July 8, 2025

**CN-296 NJSEA FIREHOUSE GARAGE
ADDITIONS AND RENOVATION**

ADDENDUM No. 1

E1.1

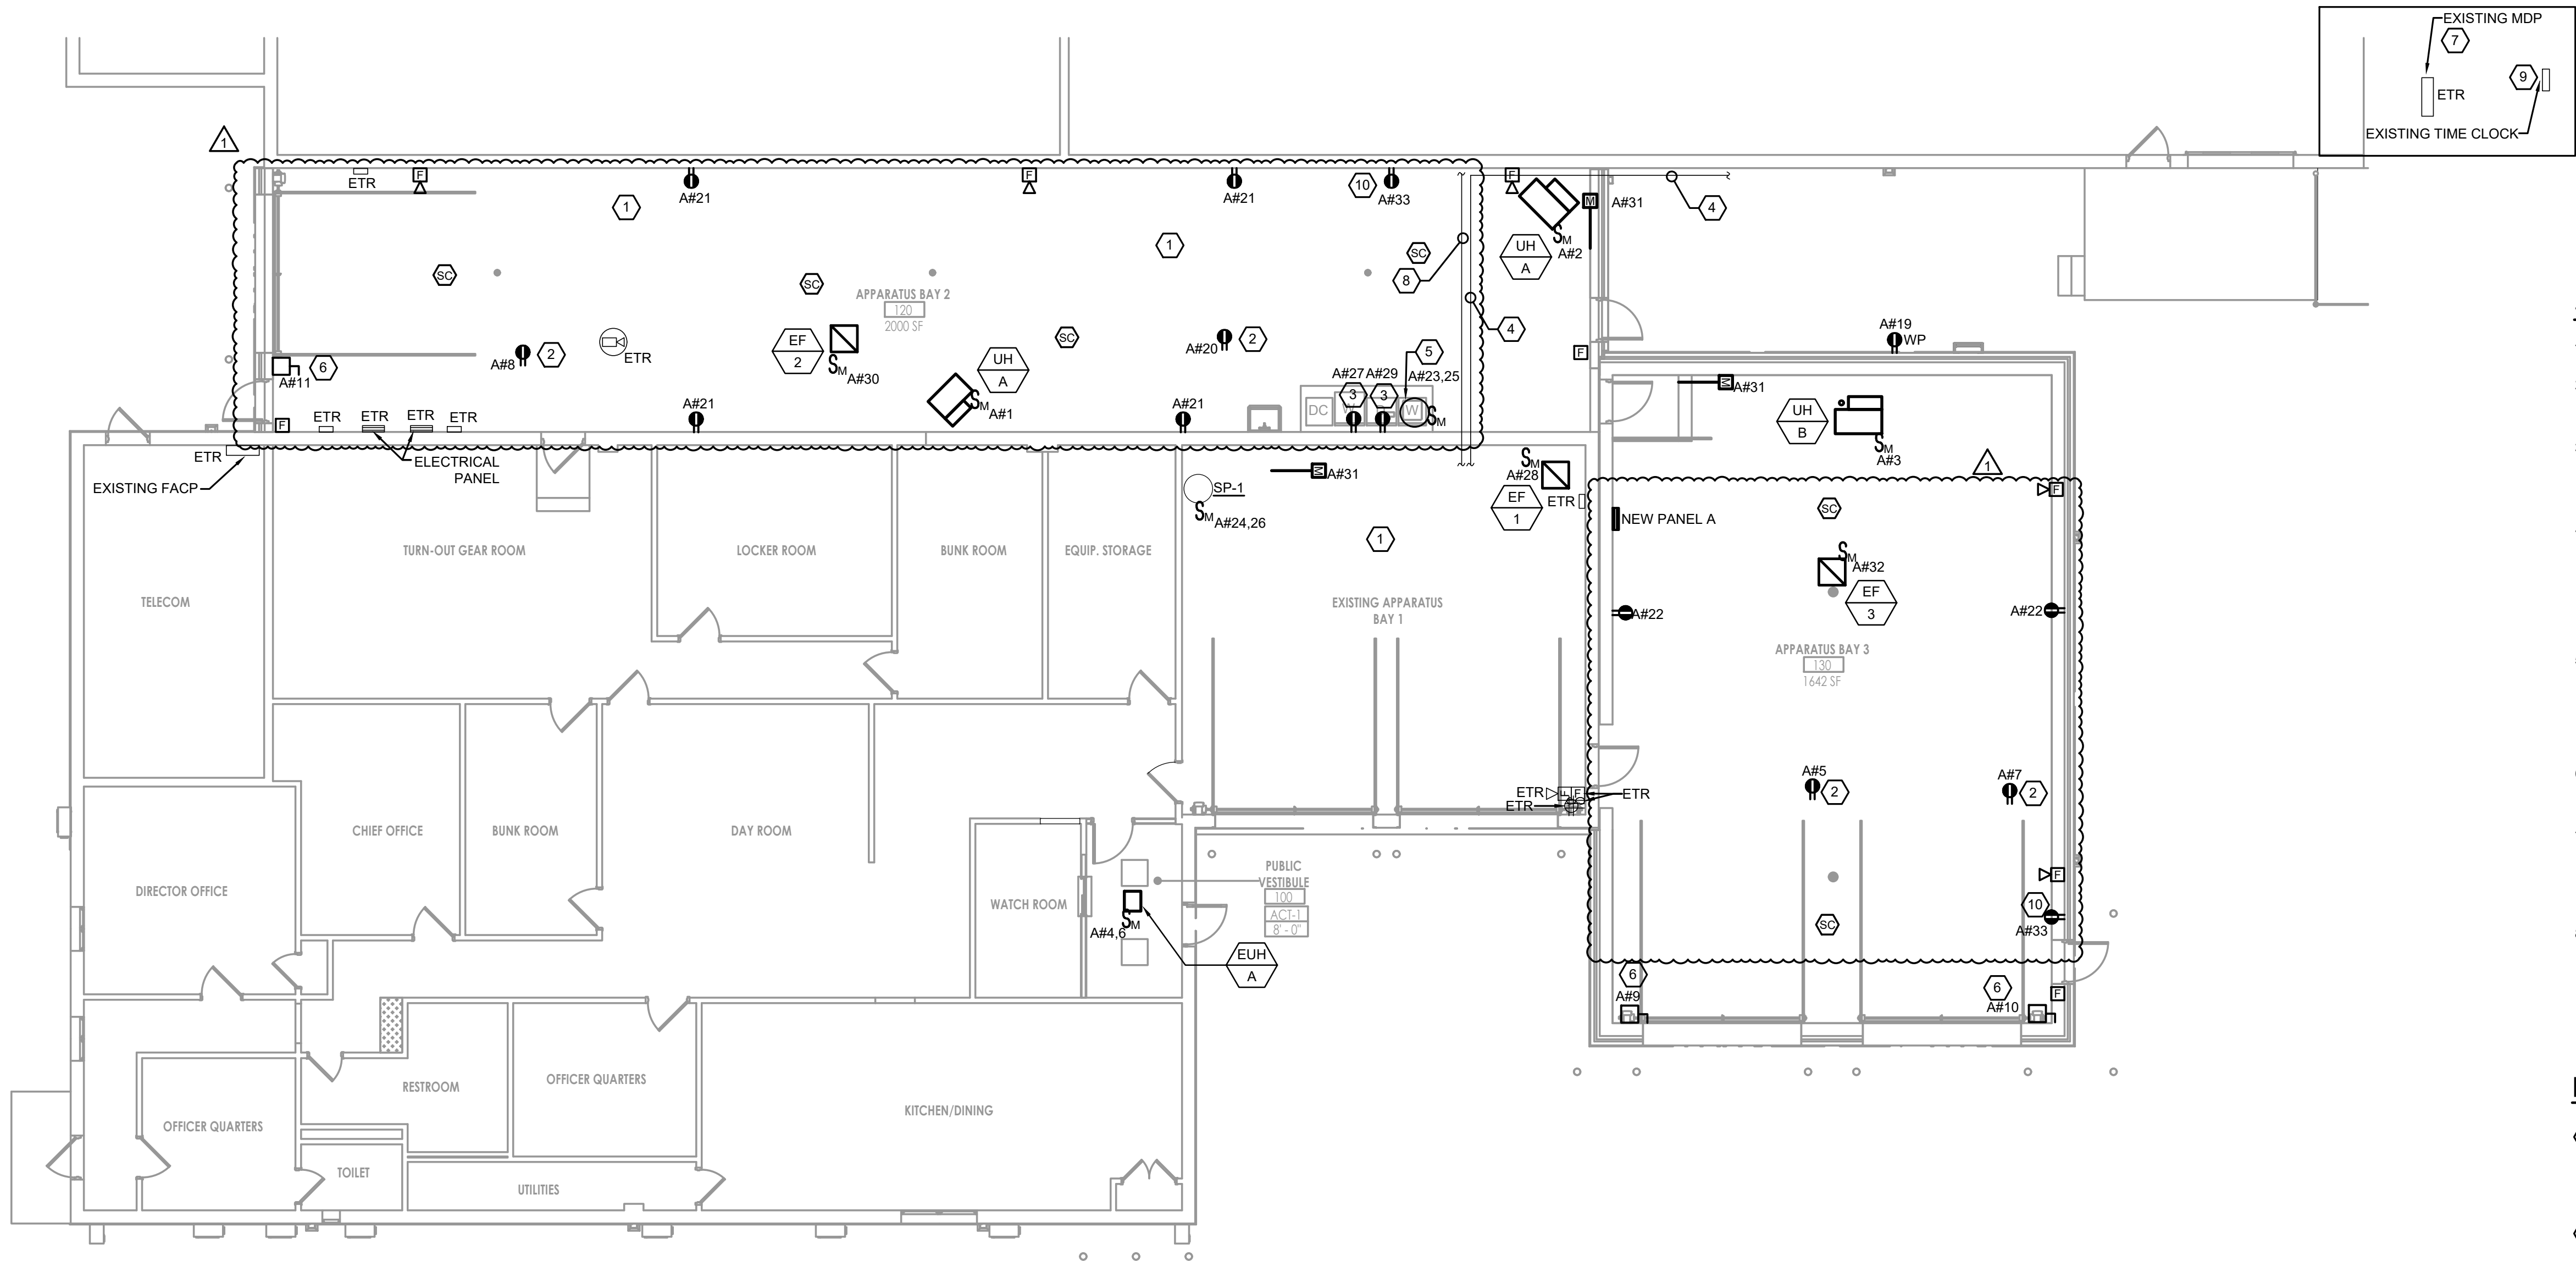
E1.1 Energy Compliance Sheet - Issued with this July 8, 2025 Addendum No. 1.

DATE	DESCRIPTION
1 6/28/2025	REVISED AS PER DCA COMMENTS

ELECTRICAL POWER PLAN

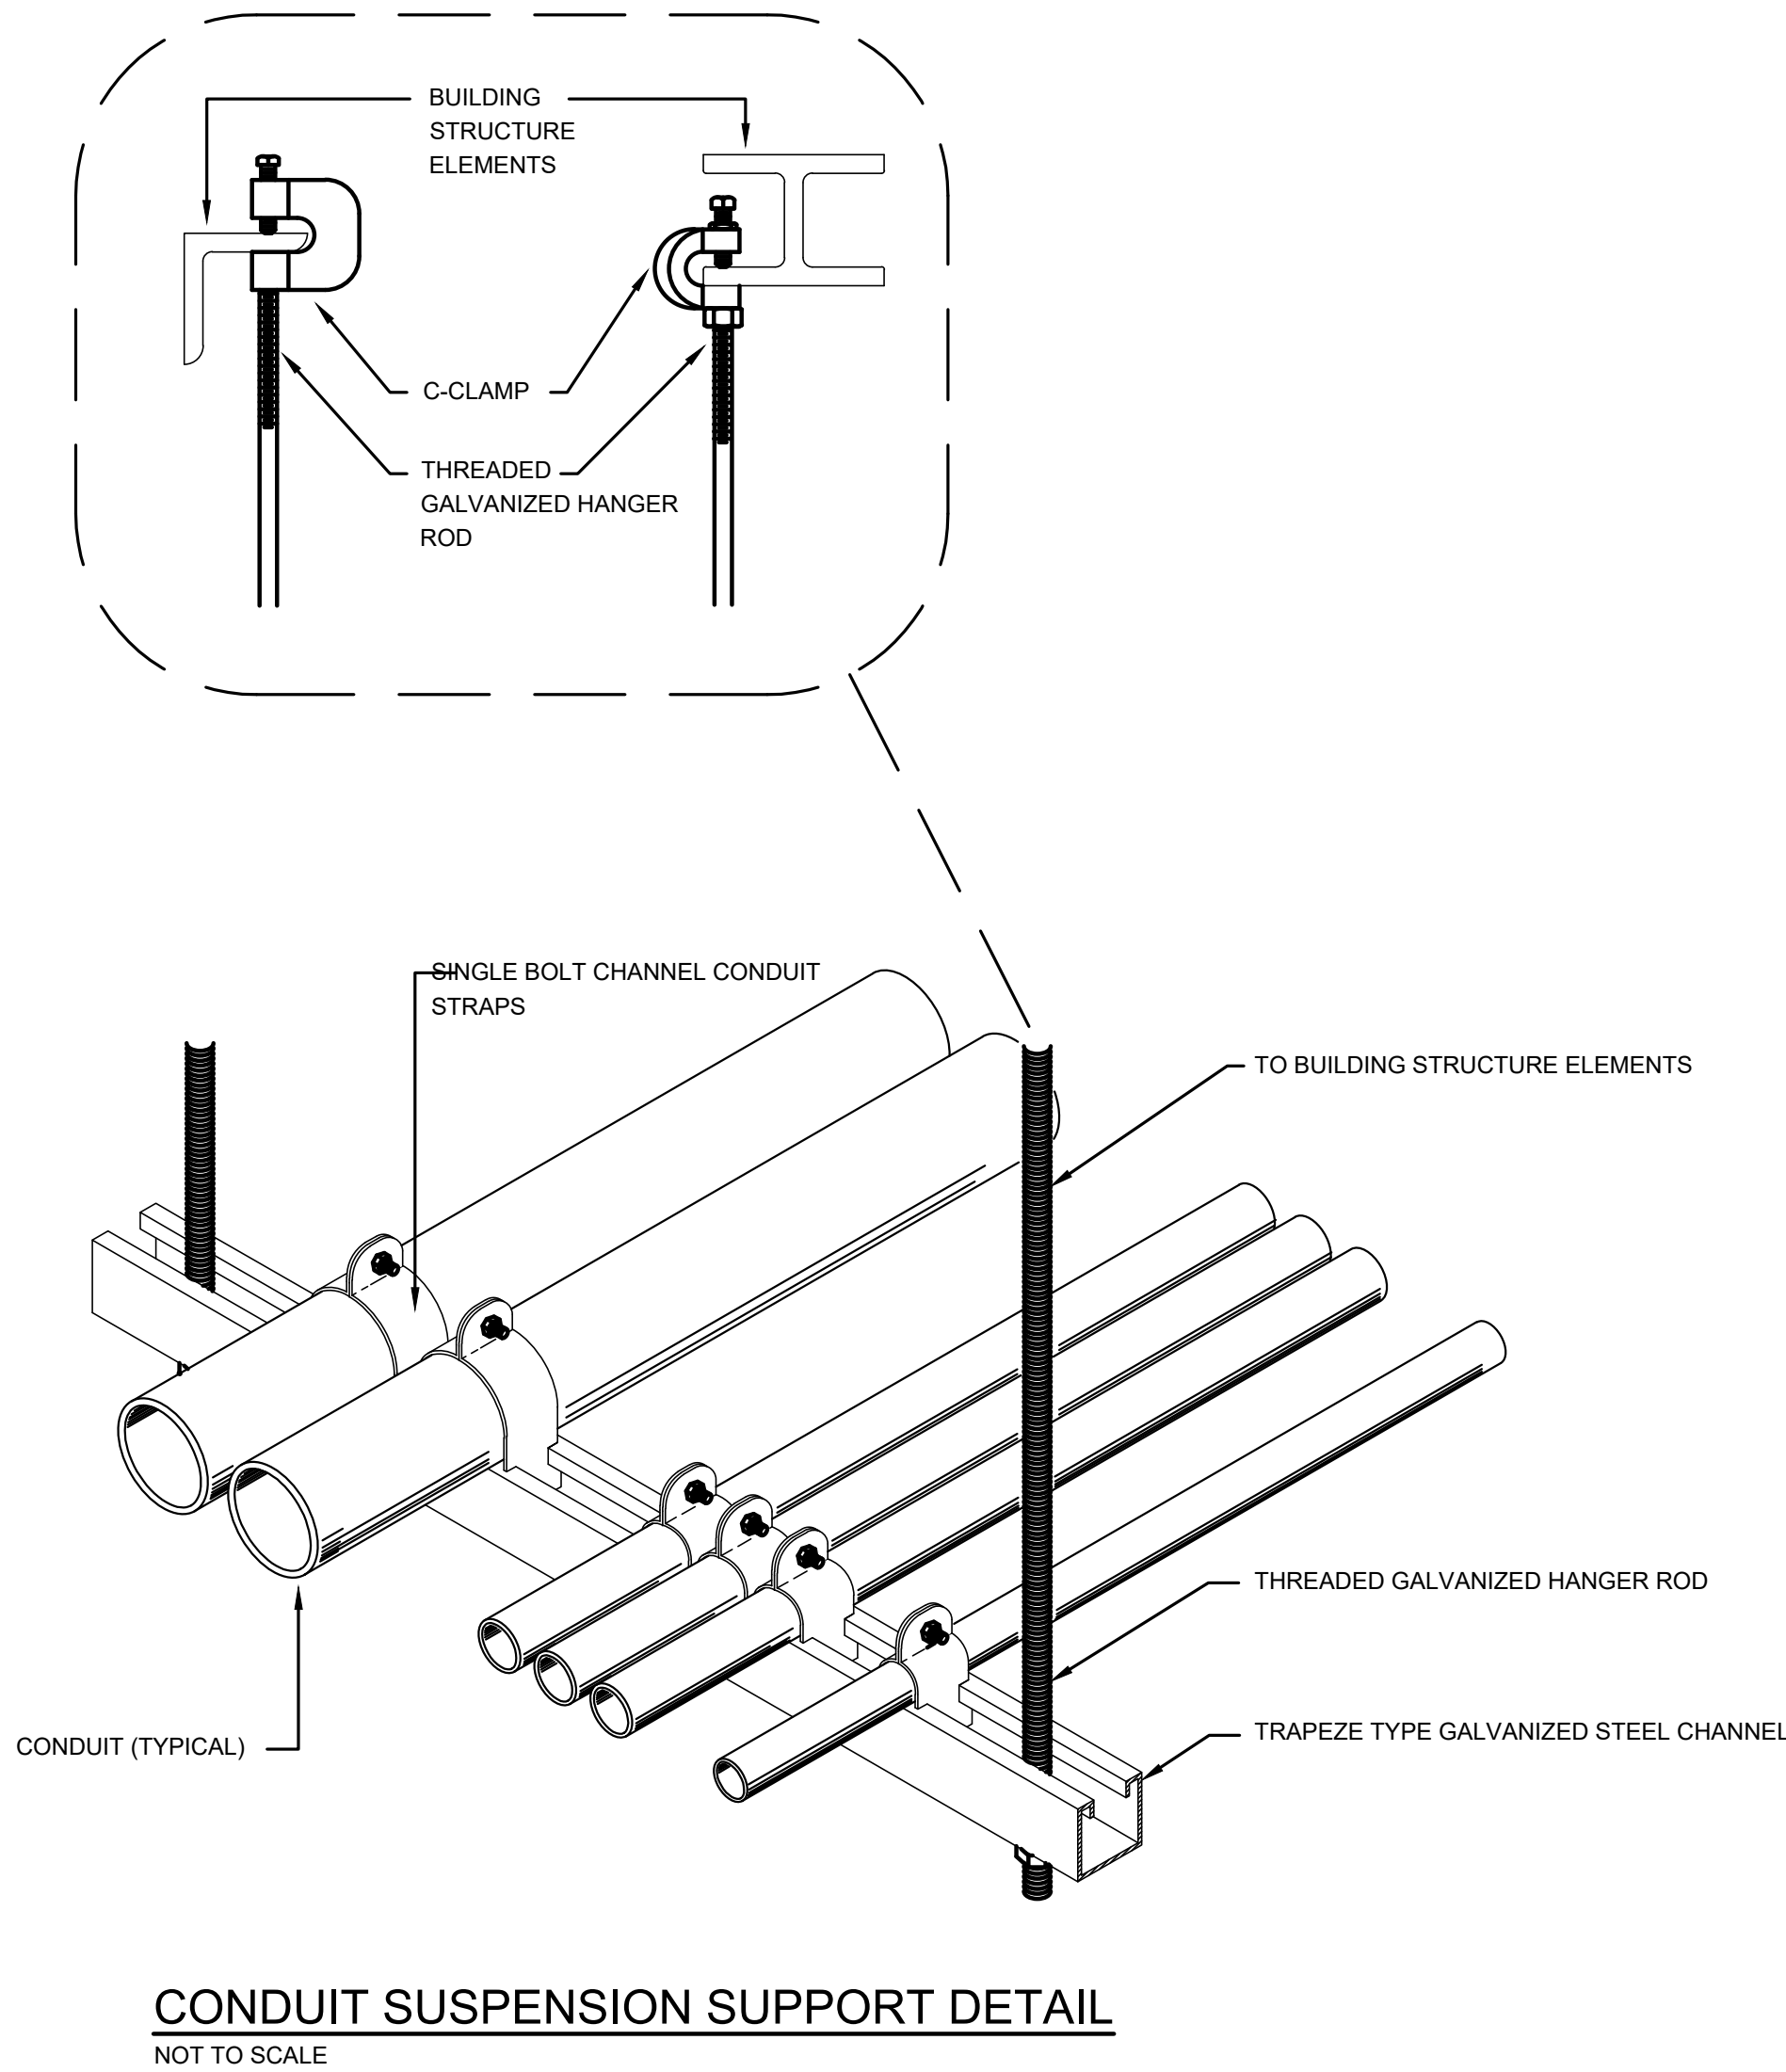
E3.0 Power Plan - Issued with this July 8, 2025 Addendum No. 1.

REV	DATE	DESCRIPTION
1	6/28/2025	REVISED AS PER DCA COMMENTS
